| Final Sign off of EPC Site Plan | | | |

Per the official notice of decision dated July 15, 2021 for Major Amendment to a Site Plan-EPC please find the following responses addressing the conditions of approval for project #2021-005301/SI-2021-00452 for a submittal action to DRB for Final-sign off for Site Development Plan- EPC:

| | NM 528 AND ELLISON 3615 HWY 528 SITE PLAN - EPC | DRAWN BY LN DATE 08/02/2021 DRAWING 2014069-SPE |

| | | SHEET # C4 |

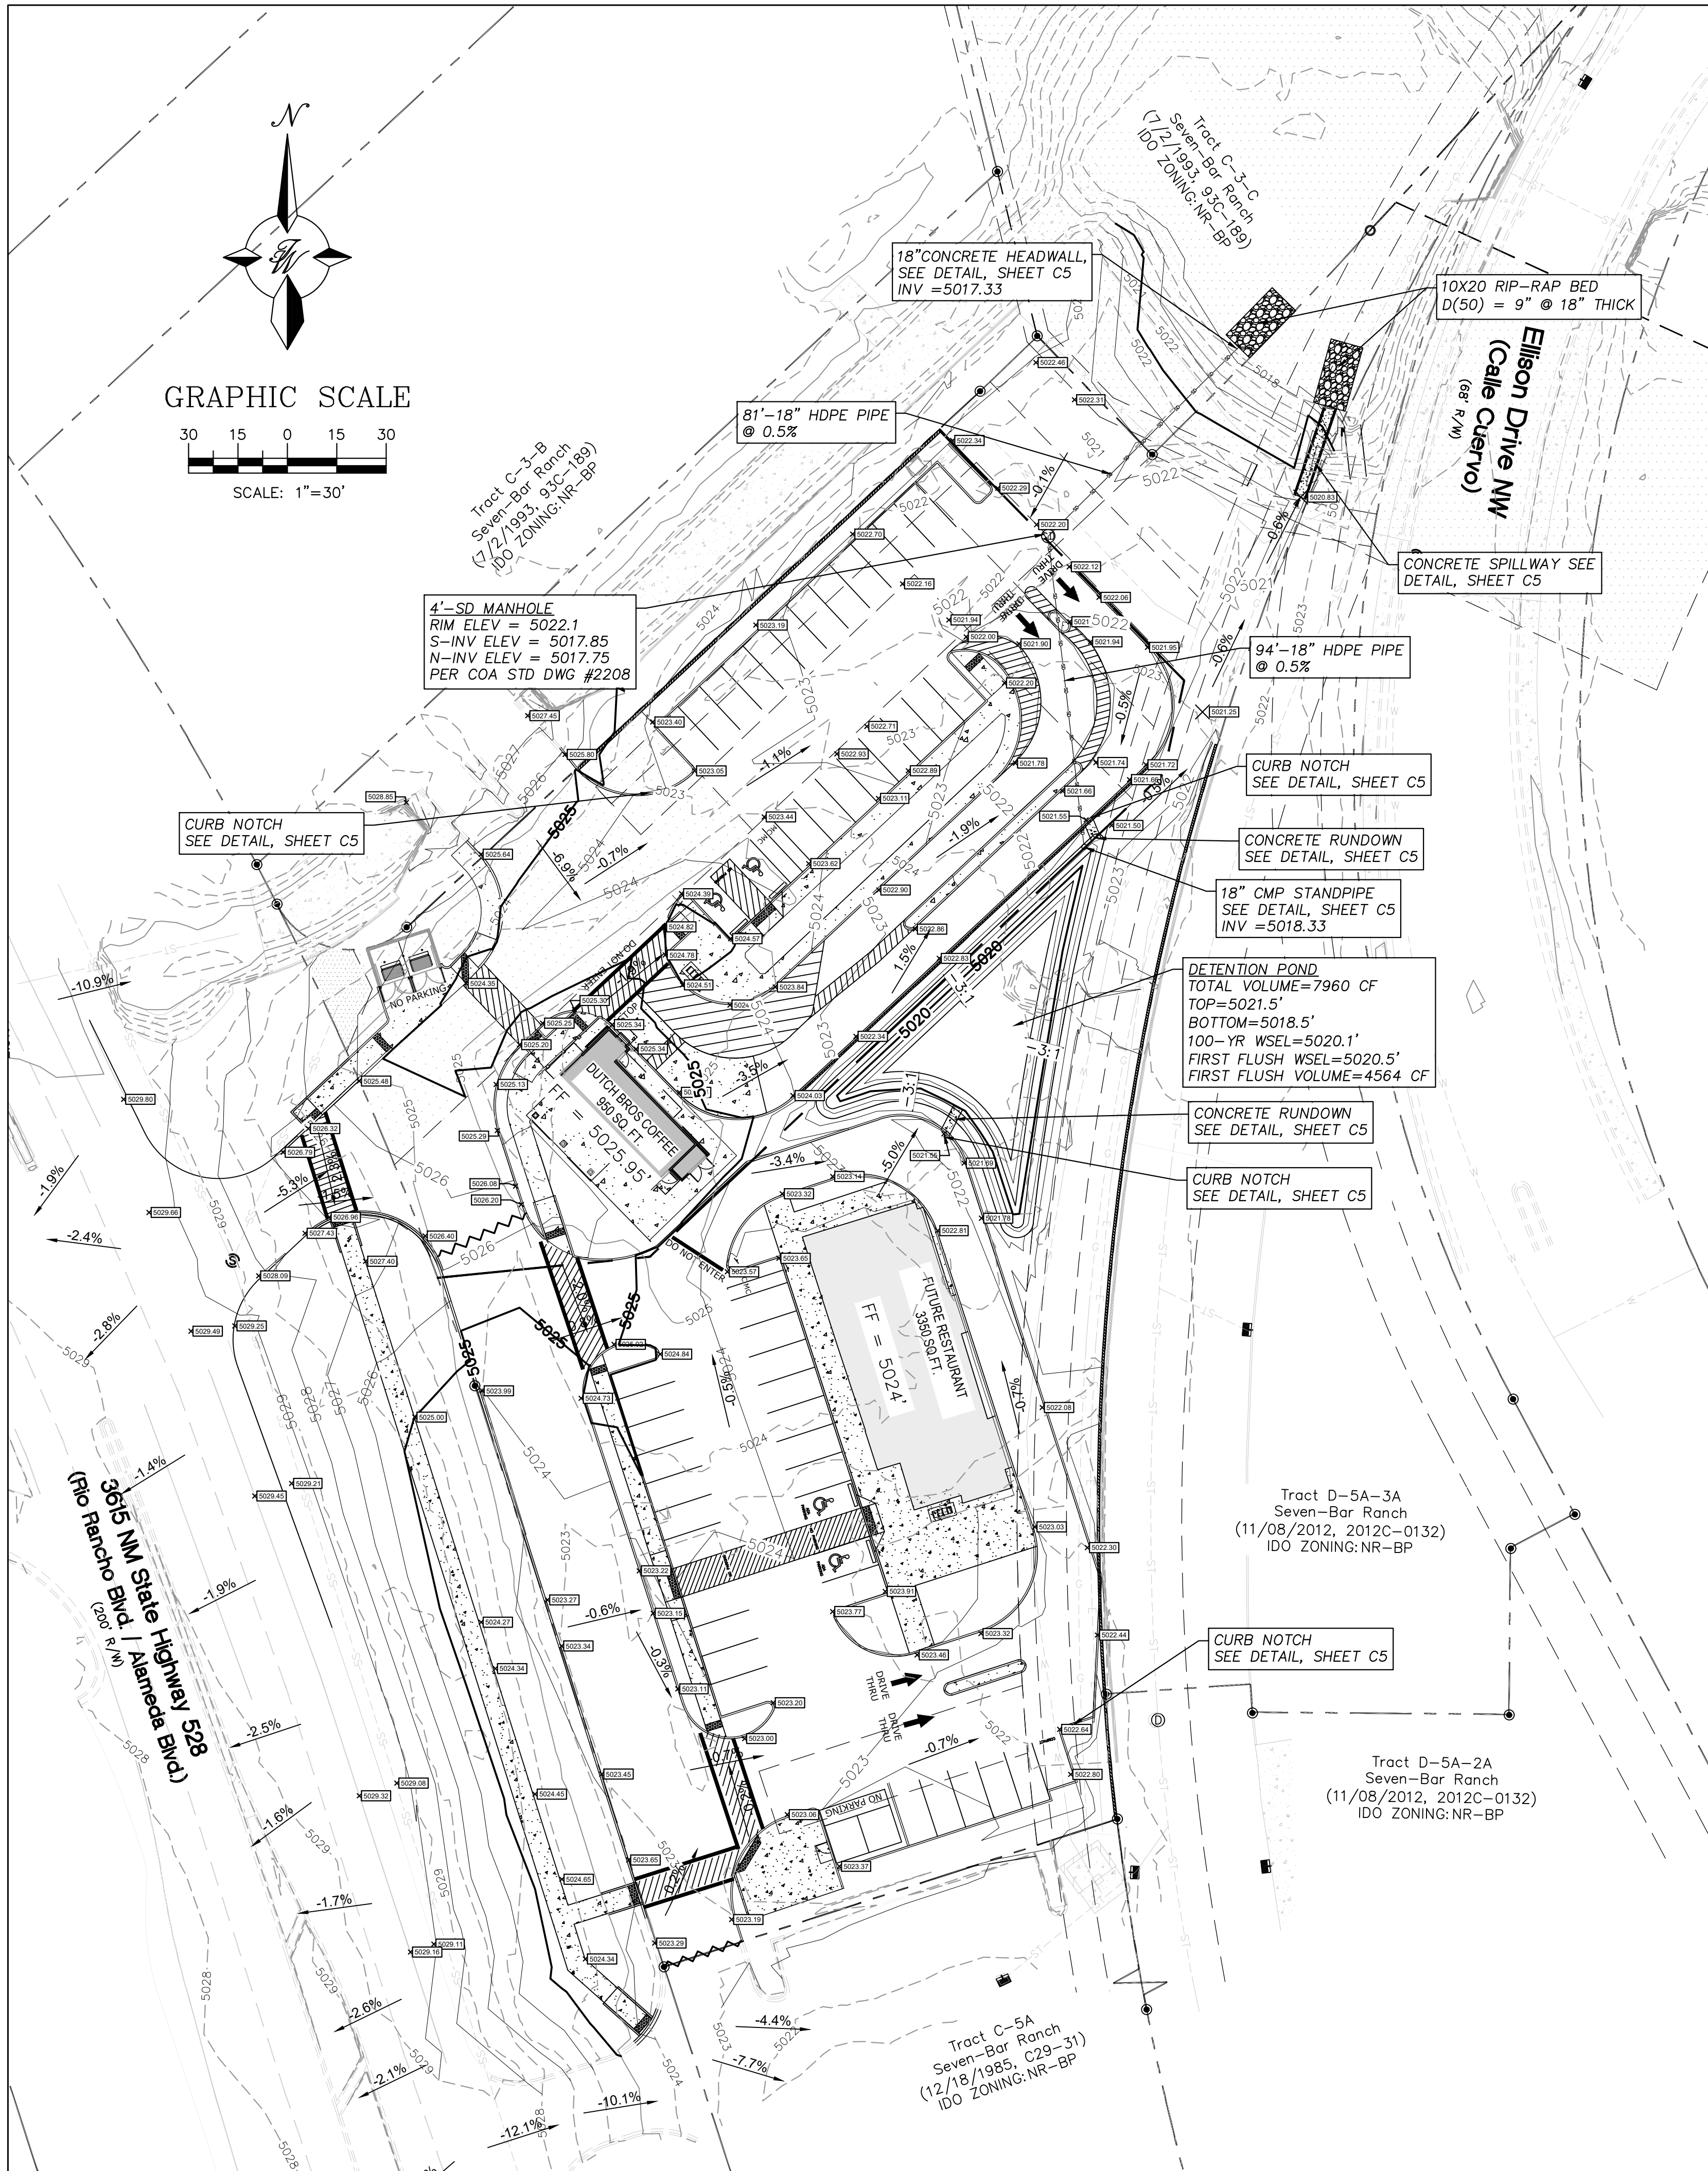
Response: Acknowledged, see note 18 sheet C1.
12. Grading and drainage plan: Curb notches shall be shown in the same location as on the landscaping plan.

Response: Acknowledged, see grading & drainage plan and landscaping plan sheets C4 and LS-01.
13. CONDITIONS FROM THE CITY ENGINEER / TRANSPORTATION:
- a. A combination of the two restaurants shall require a Traffic Impact Study. Any infrastructure that would be required as part of the study shall be placed onto an infrastructure list.

| | TIERRA WEST, LLC 5571 MIDWAY PARK PL NE ALBUQUERQUE, NEW MEXICO 87109 (505) 858-3100 www.tierrowestllc.com | SHEET # C6 |

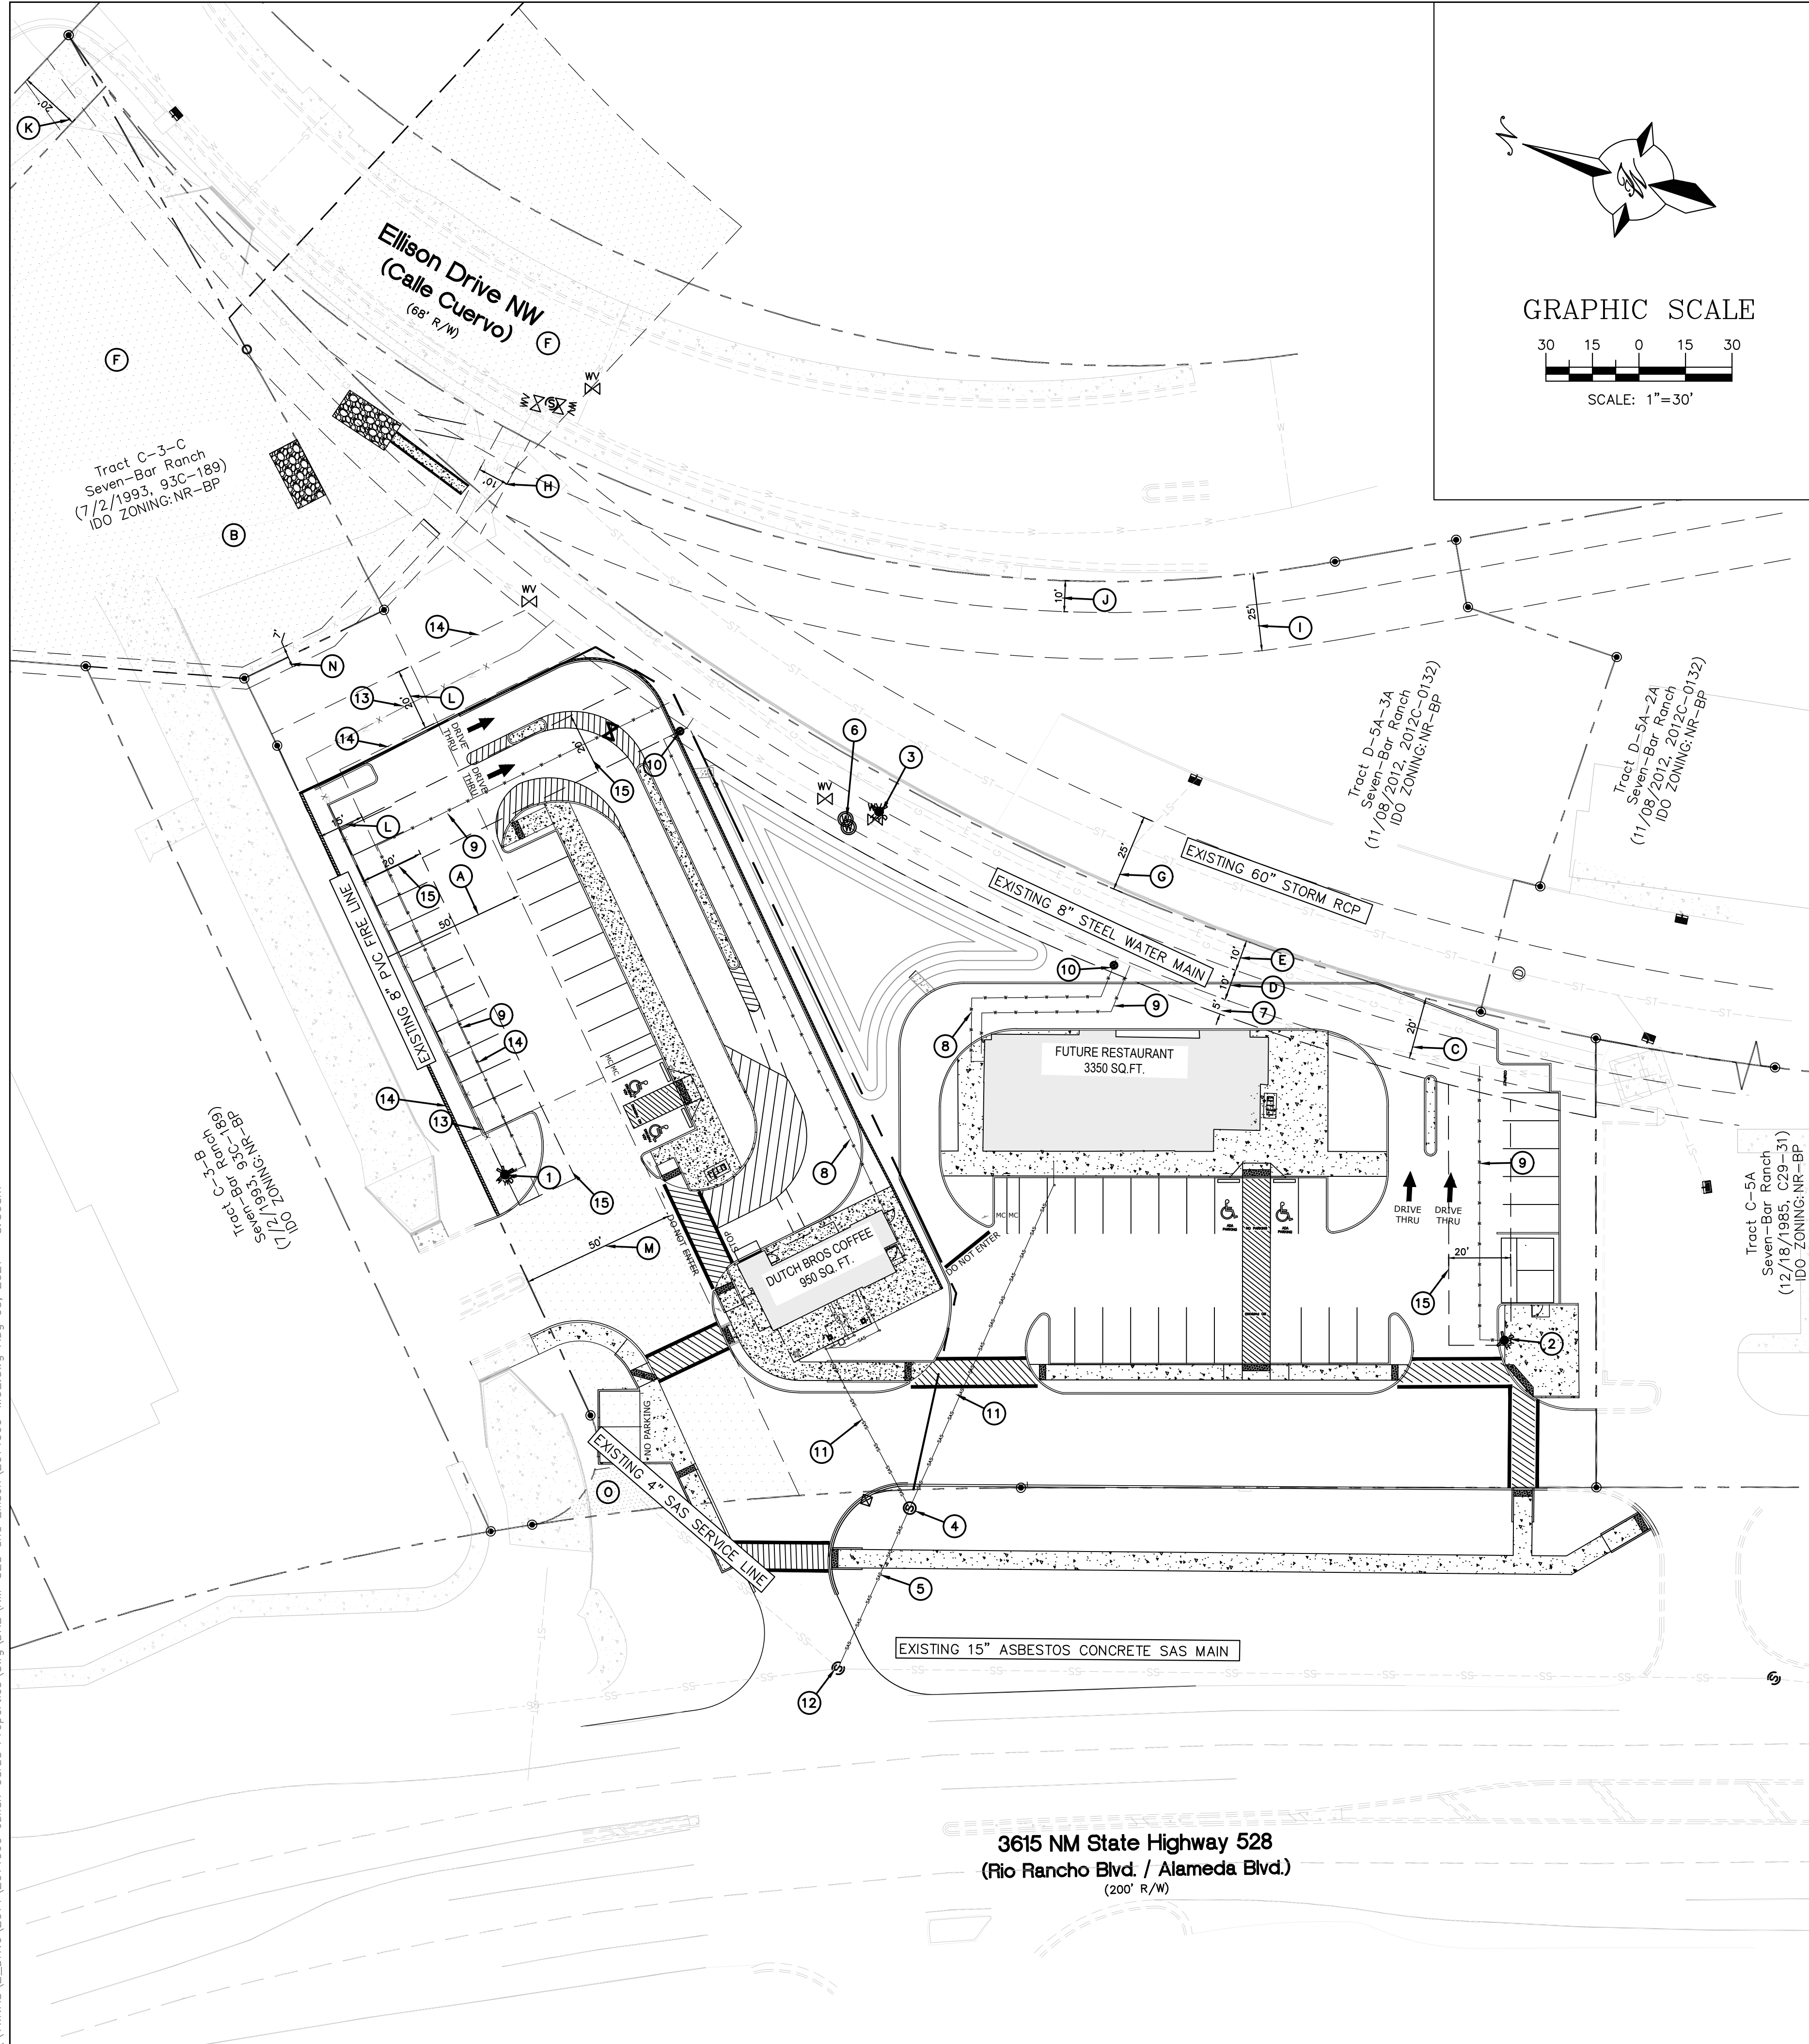
- b. The existing AMAFCA drainage easement needs to be shown on the site plan. Any improvements within the Easement will require coordination with AMAFCA and License Agreement

Response: Acknowledged, see existing easement keyed note B, sheet C6.
